Our Ref: 2018/516796

Re. Modification 1 to concept approval for UTS Blackfriars Precinct Research Building, Chippendale (SSD 6746)

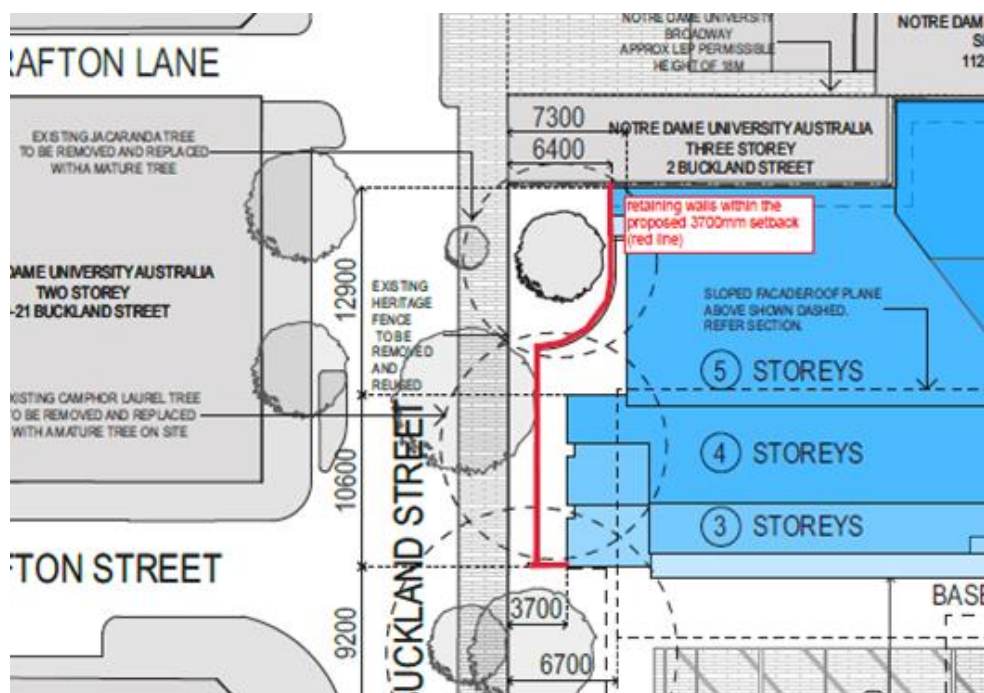
- c) Consent condition A7 (b) requires a setback of 9.29m or the distance required to retain trees T33 and T34. The proposed modification removes both T33 and T34, and seeks to reduce the setback to a minimum of 3.7m.

It is noted that the reduced dimension is not accurate. There are retaining walls proposed within the 3700mm zone that create a sunken garden 5.94m below street level and “light wells” to the basement levels (see below – red line).
